January 5, 2022

Ref: 29011.04

Re: Siland Recreation Facility – Response to EAF Comments

**Survey Map**

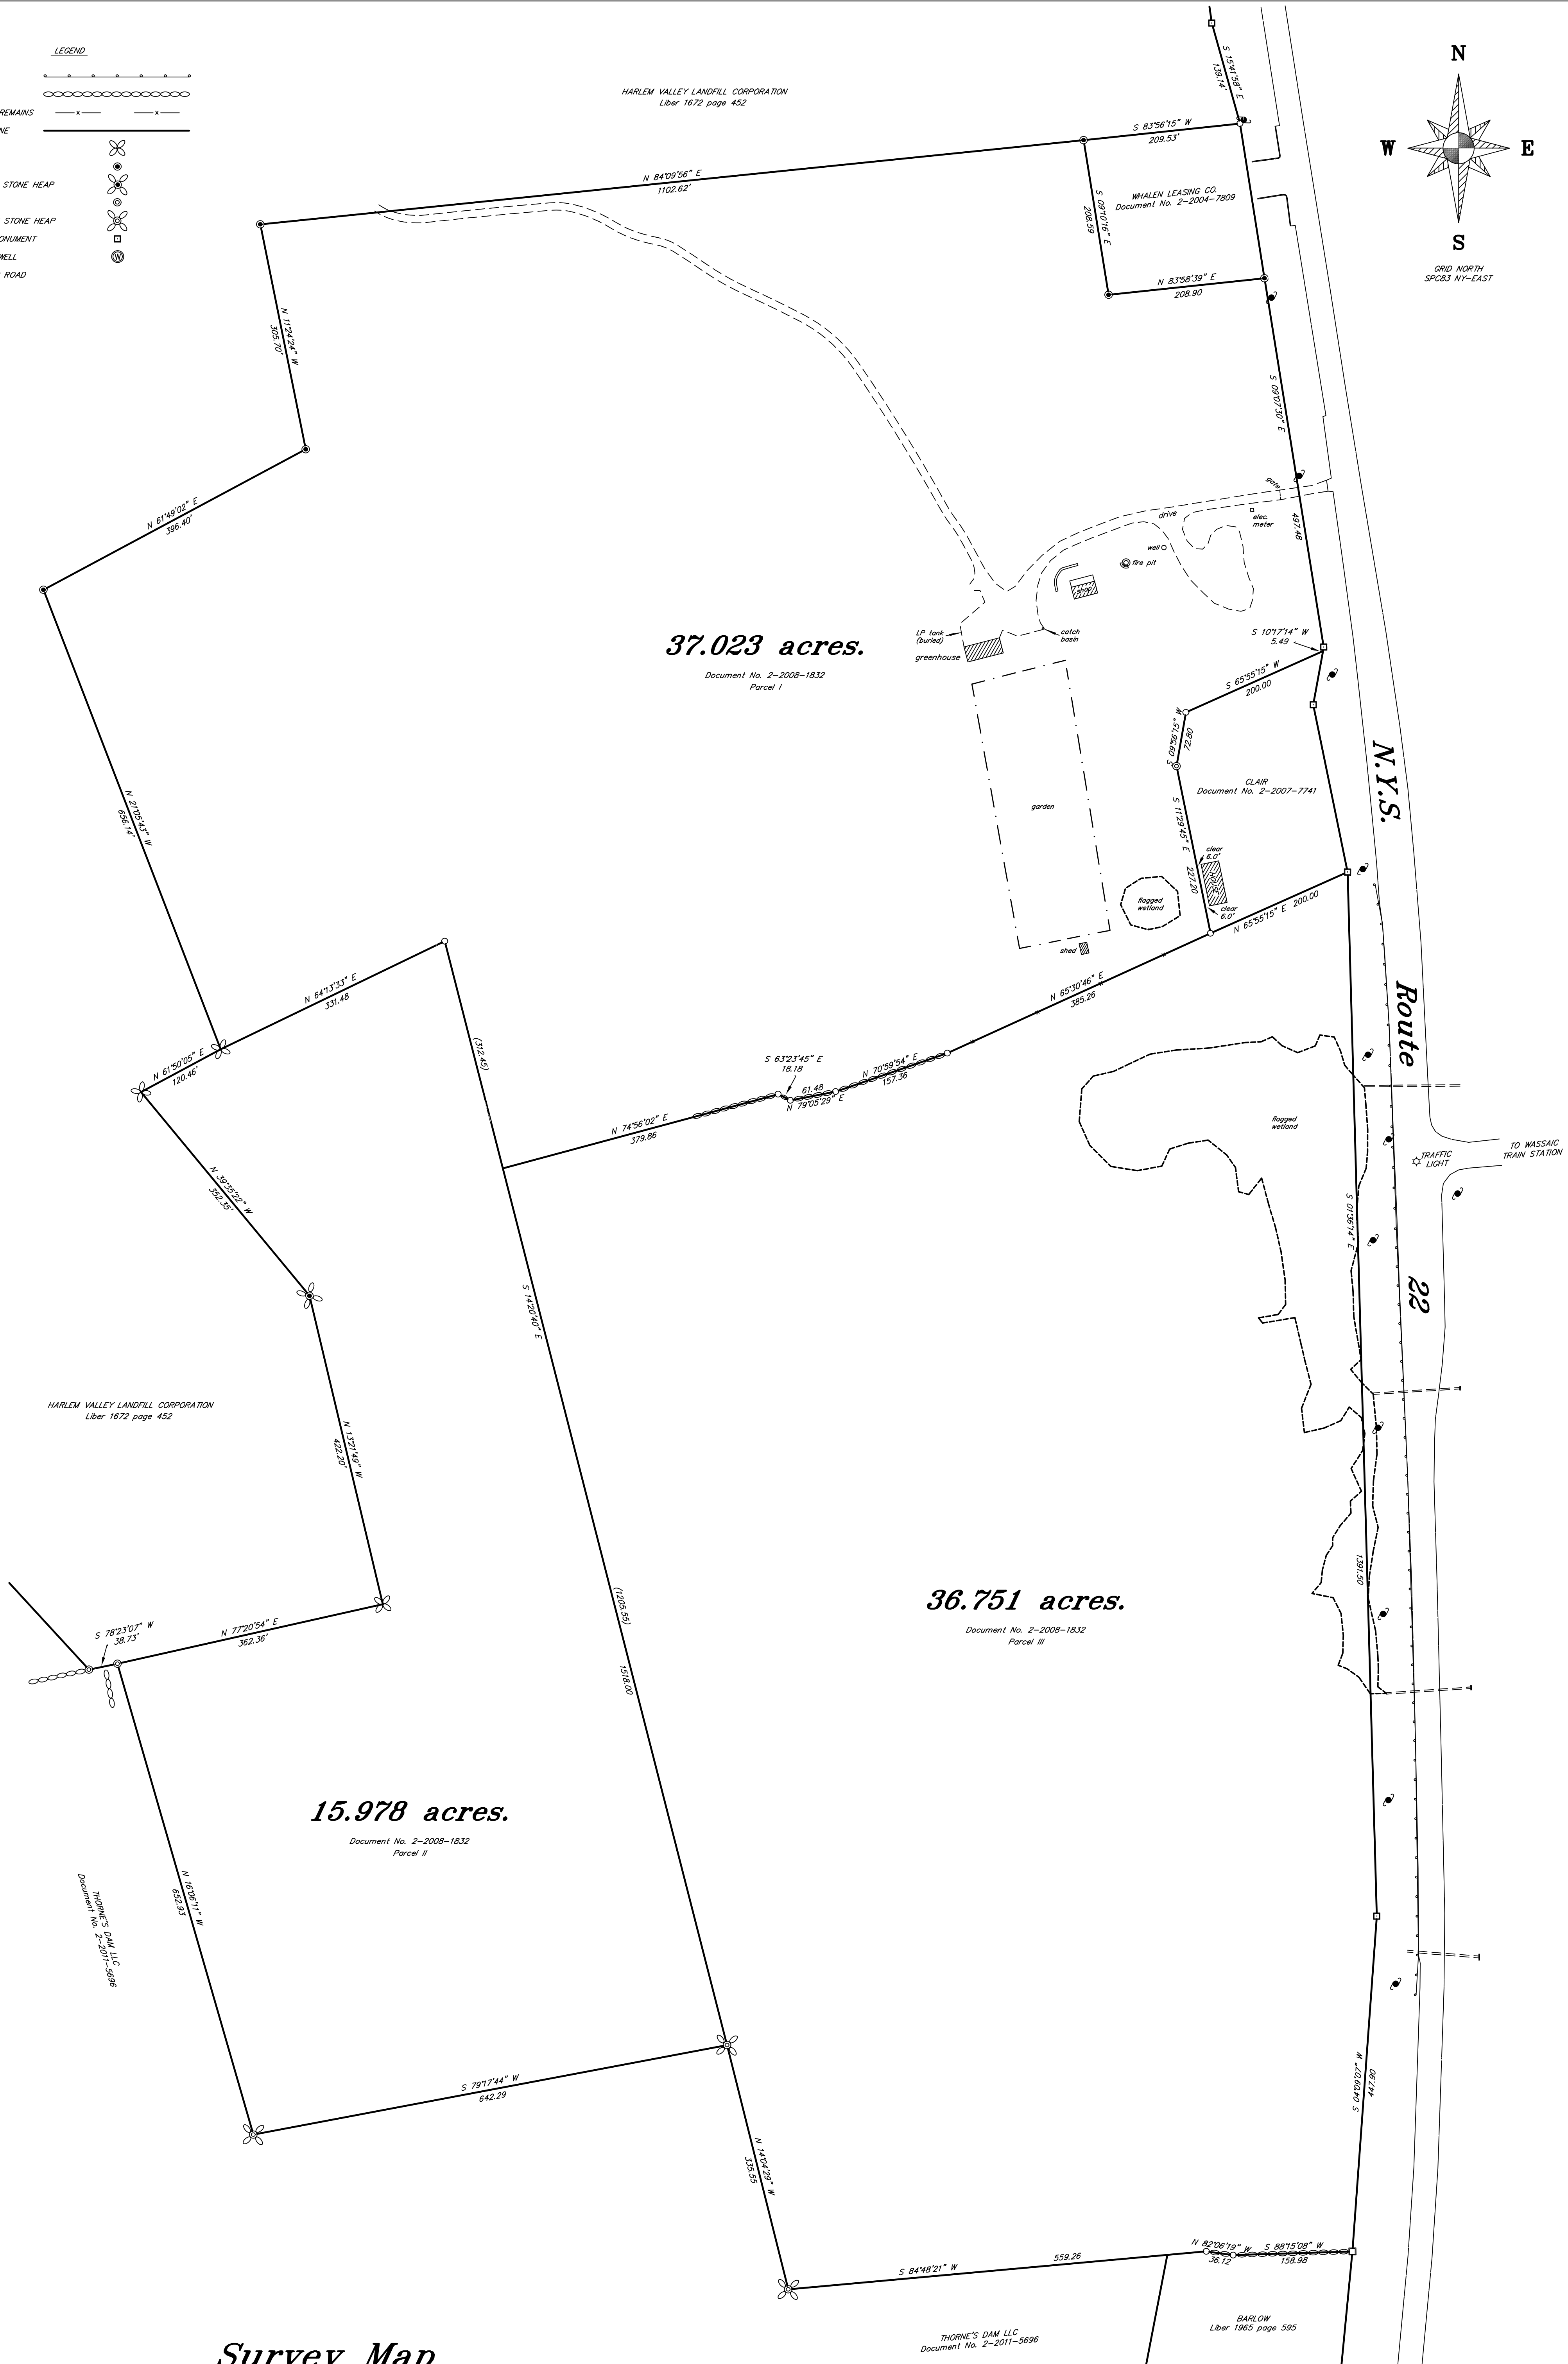
Comment 4: The deed for the Siland property identifies three separate parcels. The tax map indicates only one parcel. The project mapping appears to identify two (2) parcels. Further explanation should be provided. **[Some clarity has been provided. As indicated below, it is still not clear from a mapping/plan standpoint]**

**Response 4: The property line between Parcel I and Parcel II has been removed to show consolidation per the tax map. A plan identifying parcels I, II, and III by Kirk Horton, dated July 6, 2006, revised through October 17, 2017 is provided for reference.**

Plan View for Cross Sections

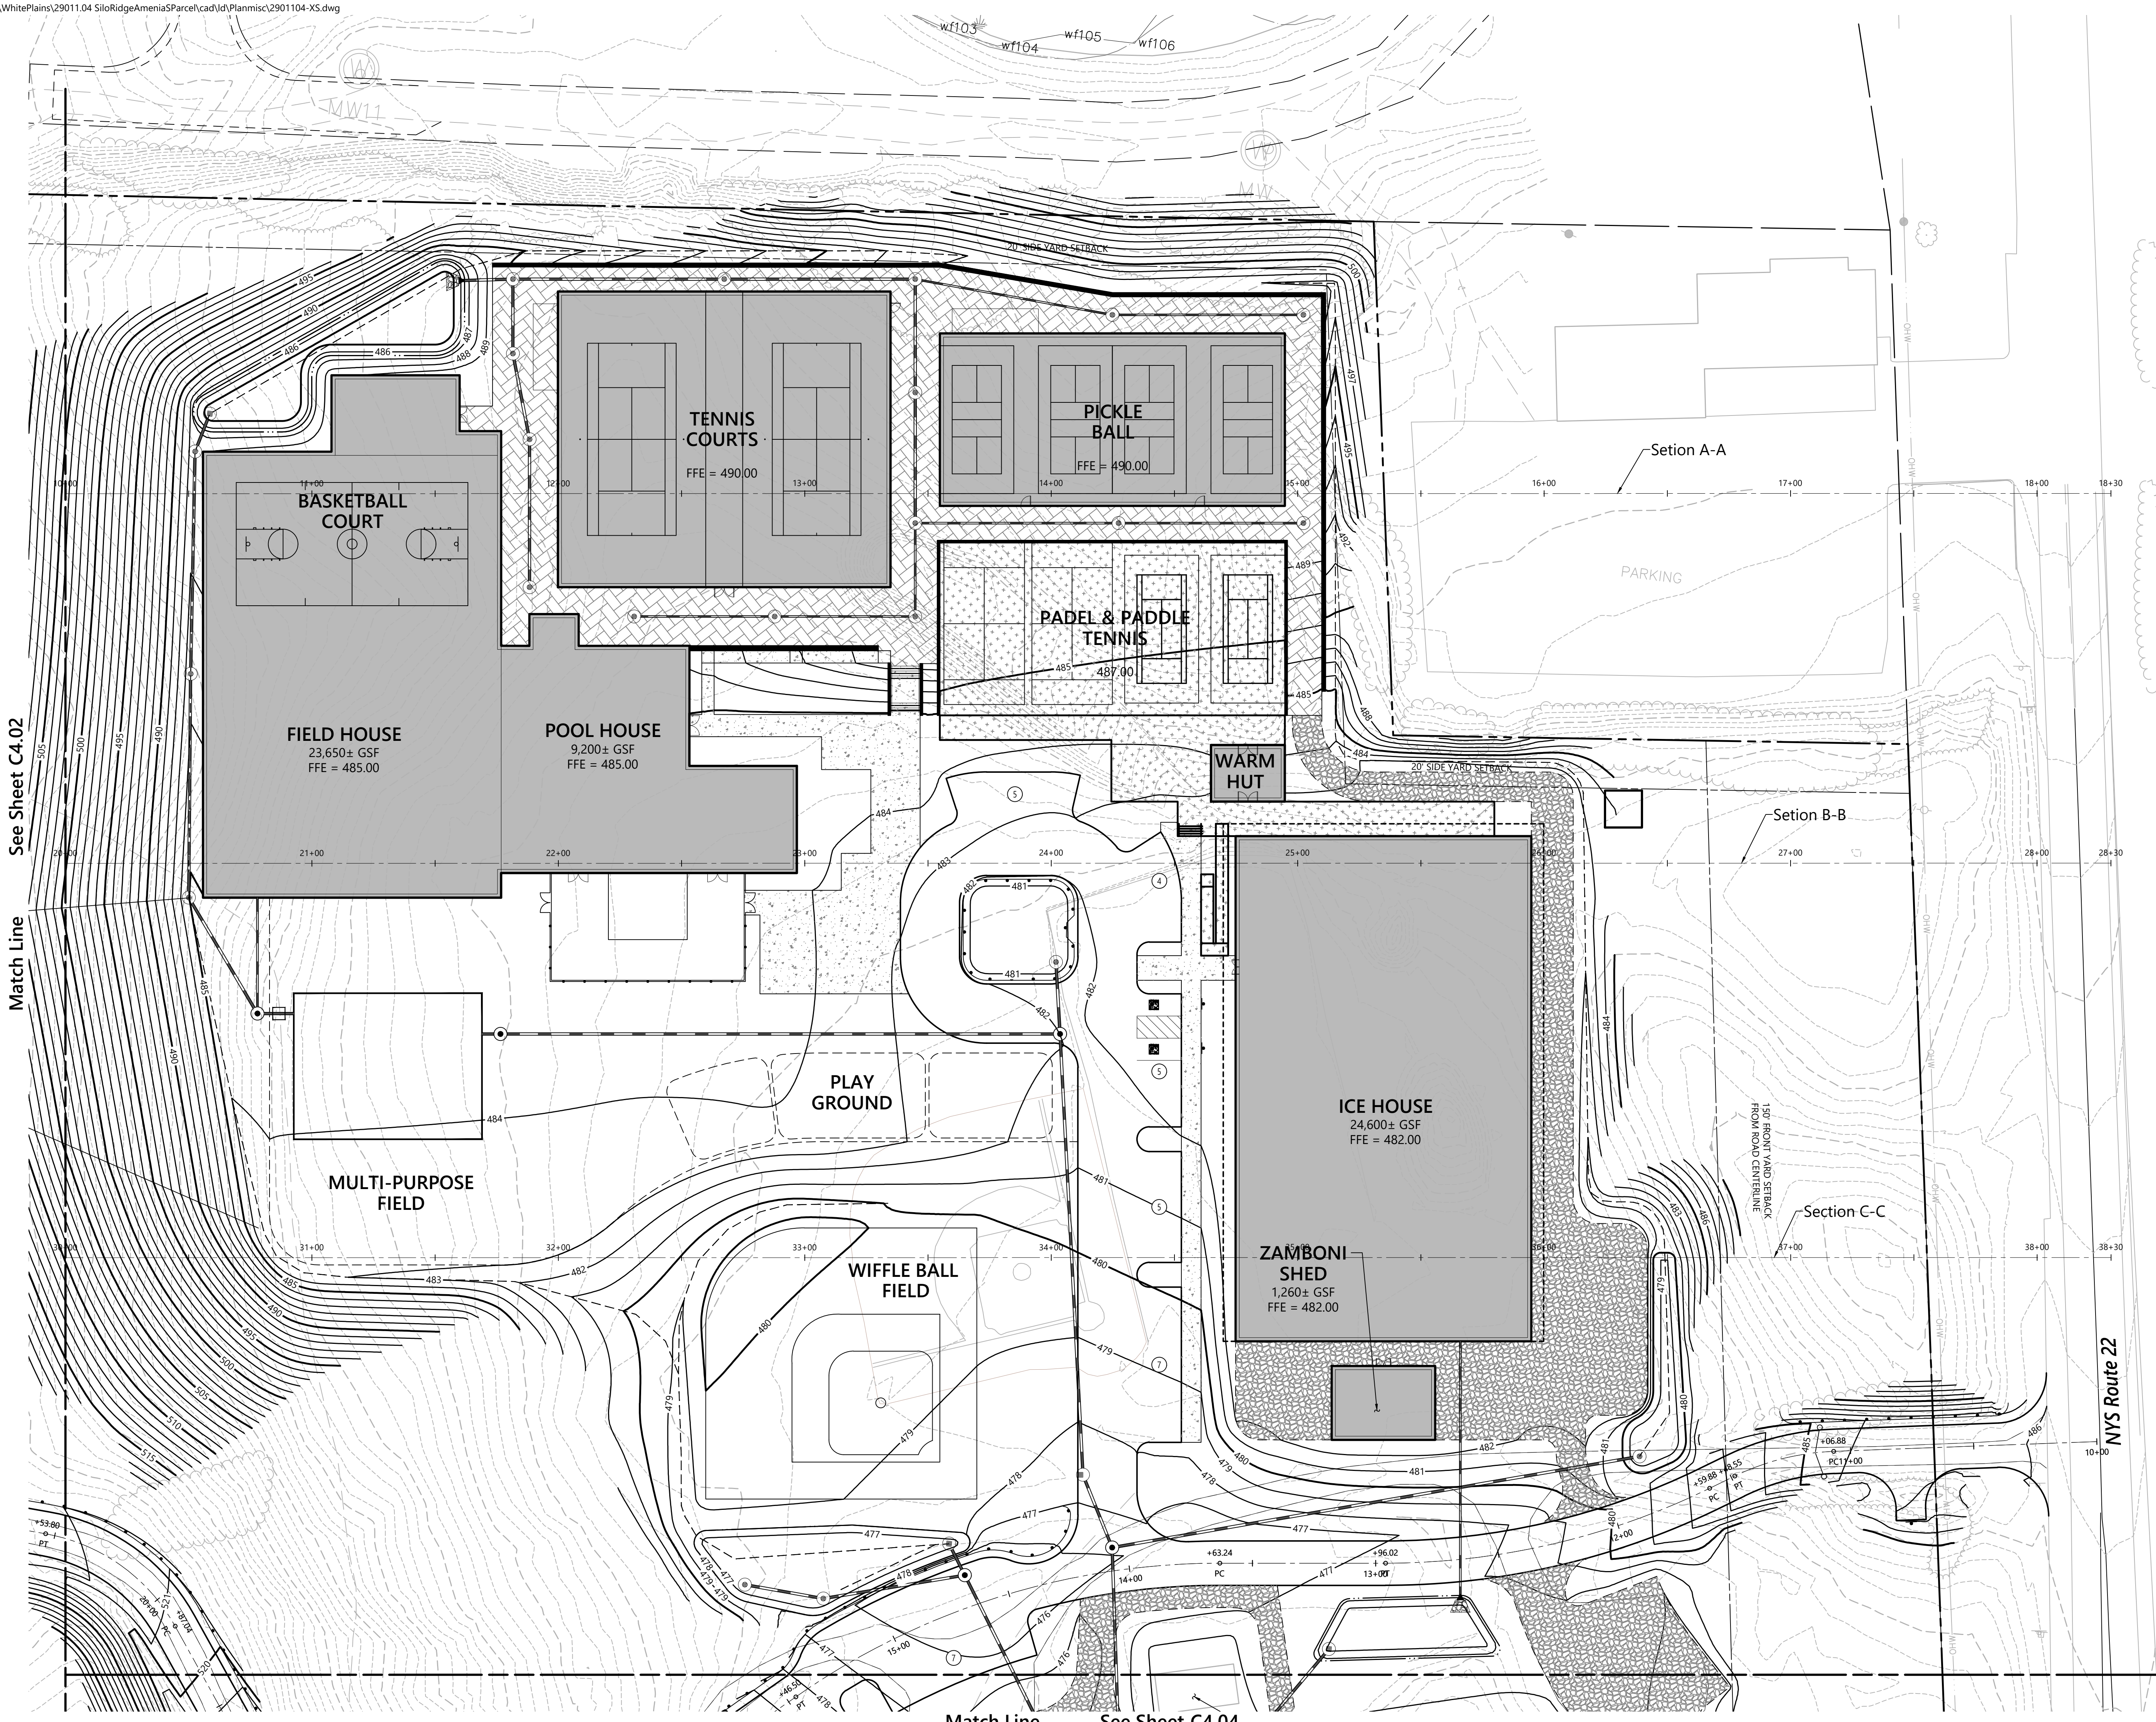
Comment 17: Future submittals should include landscaping and lighting plans and some visual analysis associated with the various Scenic Overlay Districts. **[Landscaping and lighting plans have been included in this submittal. There are some minor issues with the plans overall, we take no exception to their form and content. No visual analysis of impacts associated with the Scenic Overlays was provided.]**

**Response 17: The visual analysis associated with the Scenic Overlays is provided with the revised EAF. Additionally, proposed cross sections are included as an attachment to this response to comments.**
